Chatten-Brown Law Group, APC
Isabella Coye | Associate
325 W. Washington Street, Suite 2193
San Diego, CA 92103
igc@chattenbrownlawgroup.com

February 27, 2026

Re: Comments Regarding the Proposed Anaheim Hills Festival Specific Plan Amendment Project

(Hills Preserve project marked as A1; Festival Center Project marked with an orange circle; Alleged road closure marked with a red circle.³)

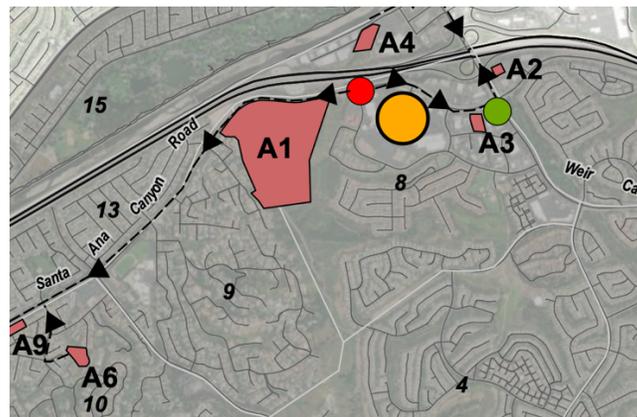
The Hills Preserve project and Festival Center Project are less than 800 feet apart at their closest points.² Yet, the Project’s Evacuation Time Analysis (“Evacuation Memo”) asserts that the Hills Preserve project would cumulatively add *zero* minutes to the evacuation time of the Festival Center Project if a “worst case” fire (i.e., one located in Deer Canyon) were to occur. Based on the Evacuation Memo’s analysis of the City’s Know Your Way evacuation planning framework, the Hills Preserve project is “expected to evacuate via alternate routes that do not intersect with the Santa Ana Canyon Road and Weir Canyon Road intersection and . . . [is] therefore assumed to have no measurable impact (0 minutes) on the cumulative evacuation times presented.” (DEIR, App’x 4.9-2, p. 12.) Rather, the Hills Preserve project is assumed to “[e]vacuate west via Santa Ana Canyon Road to Imperial Highway.” (*Ibid.*)

(Hills Preserve marked with red star; Festival Center marked with yellow star; Red line delineating Zone 9 to the left and Zone 8 to the right.)

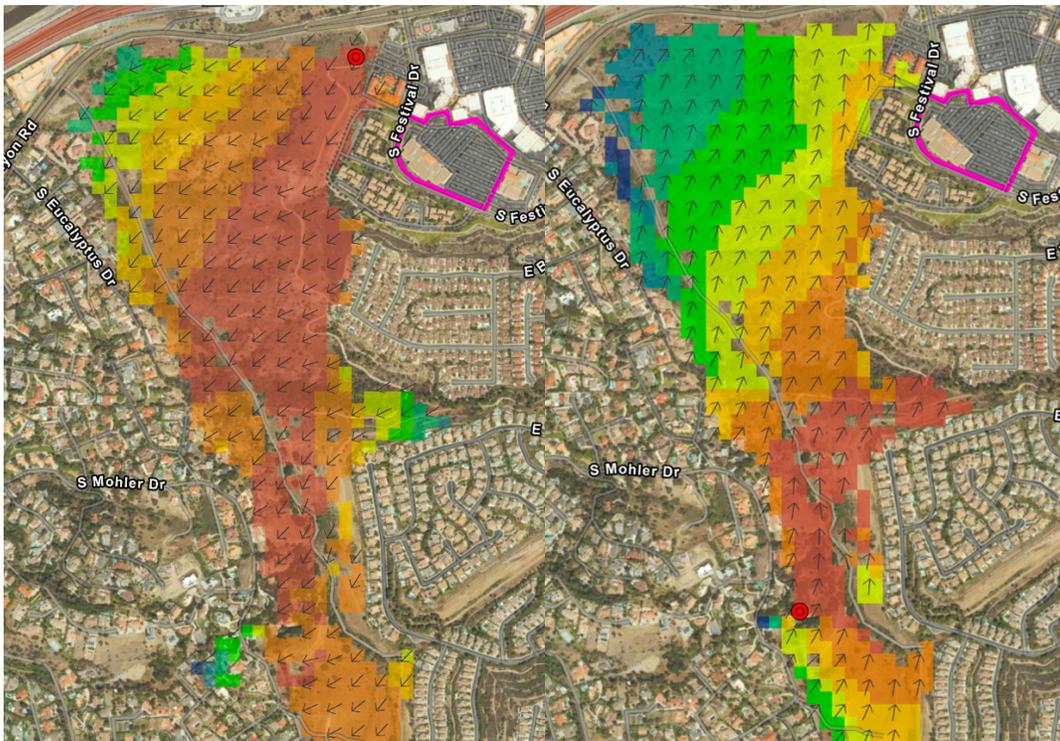
The only authority cited for this premise is a link to the City’s Know Your Way plans. (*Ibid.*) However, the conclusion that Zone 9 would evacuate west is based on a fundamental misinterpretation of these very plans. The Festival Center Project, located in Zone 8, would indeed evacuate eastbound along Santa Ana Canyon Road towards the intersection of Santa Ana Canyon Road and Weir Canyon Road.⁴ The Hills Preserve project is also proposed largely in Zone 8. However, even the Zone 9 Know Your Way plan clearly depicts that residents would *also* evacuate eastbound along Santa Ana Canyon Road towards the intersection of Santa Ana Canyon Road and Weir Canyon Road.⁵ These Know Your Way plans are depicted below and individually attached as **Exhibit 1** [Zone 8] and **Exhibit 2** [Zone 9]:

The Know Your Way plans clearly depict *all* traffic along Santa Ana Canyon Road traveling eastbound. The Evacuation Memo’s claim that the entire Hills Preserve project, which it fails to acknowledge as being largely located in Zone 8 alongside the Festival Center Project, would travel westbound is unfounded and in contrast with the maps published by the City. Indeed, the only apparent support for this interpretation is the inclusion of *one* marker indicating a road closure between the two projects, which is not adequately disclosed, but rather depicted solely in the Evacuation Memo’s Figure 7. The Evacuation Memo does not otherwise indicate why this road closure is necessary. The assumptions made regarding the fire’s origin point are similarly flawed. The Evacuation Memo presents two models to demonstrate worst-case fire scenario: one igniting in the northeast portion of Deer Canyon – between the two projects – and one igniting in the southwestern portion. (DEIR, App’x 4.9-2, p. 2.)

The Evacuation Memo *must* be revised accordingly, as the assumption that the Hills Preserve project would add zero minutes to the Festival Center Project's evacuation times is directly at odds with the very maps cited by the Evacuation Memo for support. This mistake undermines the accuracy of the entire Evacuation Memo and FEIR and necessitates scrupulous review so that the Festival Center Project's cumulative evacuation impacts may properly be assessed and disclosed.

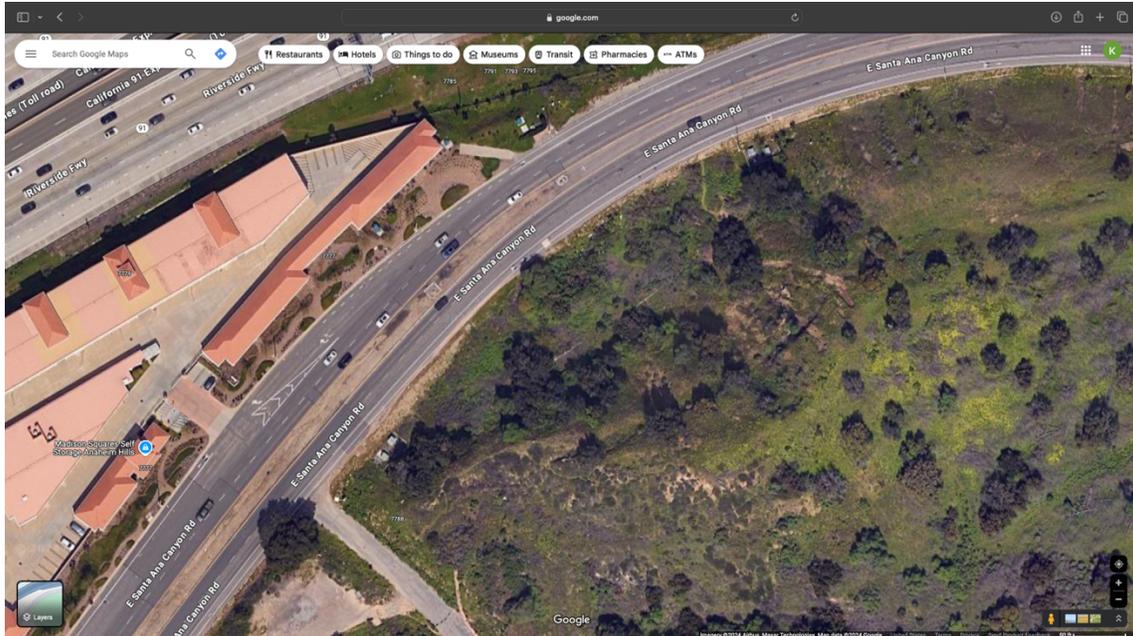
The EIR’s “Evacuation Analysis” concluded the Project would increase evacuation times in the community by 24 minutes, resulting in an evacuation time of 3.5 hours for a fire origin located immediately east of the project site. (EIR, Appendix S (“Evacuation Report”), p. 7.)

Despite the EIR’s admission that the Project would increase evacuation times in the event of a fire originating east of the site, the Evacuation Report assumed that “the proposed Project would shelter in place for the other fire origins evaluated in the Firesafe Planning Solutions fire modeling scenarios, which would therefore result in no increase in evacuation travel times along Santa Ana Canyon Road.” (*Ibid.*) This further conflicts with the Attorney General’s Guidance to “[a]void overreliance on community evacuation plans identifying shelter-in-place locations. Sheltering in place... should not be relied upon **in lieu of analyzing and mitigating** a project’s evacuation impacts.”⁸

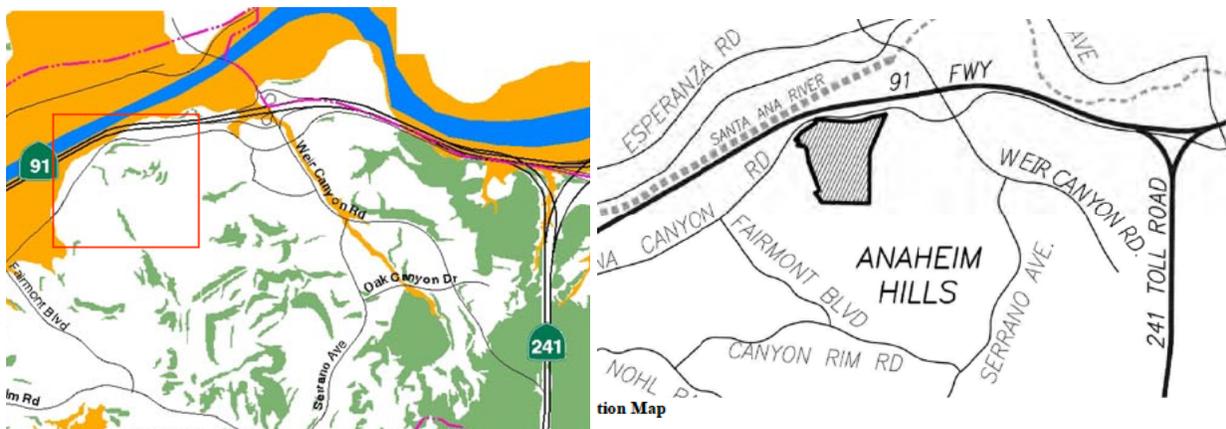
The EIR admits the Project would result in significant impacts to VMT. (EIR, p. 4.15-13.) Yet, the EIR fails to incorporate all feasible mitigation measures to address VMT. Furthermore, the five professed “mitigation measures” in the EIR fail to provide any meaningful VMT mitigation, as they rely on “soft” unenforceable actions like “marketing” and “providing information.” This is unacceptable, especially given the State's climate emergency and the Project's location in a high VMT area, contrary to the State's goals.

The Project must incorporate feasible mitigation, including the VMT-related measures listed in the California Air Resources Board's 2022 Scoping Plan. This includes unbundled parking. The EIR claims “unbundled parking was evaluated; however, it would be inconsistent with AMC Section 18.42.030.0203, which addresses residential parking requirements.” (EIR, p. 4.15-14.) This conclusory statement about this mitigation measure's feasibility lacks any evidence, especially given that the Project is relying on *several* deviations from other sections of the City's municipal code.
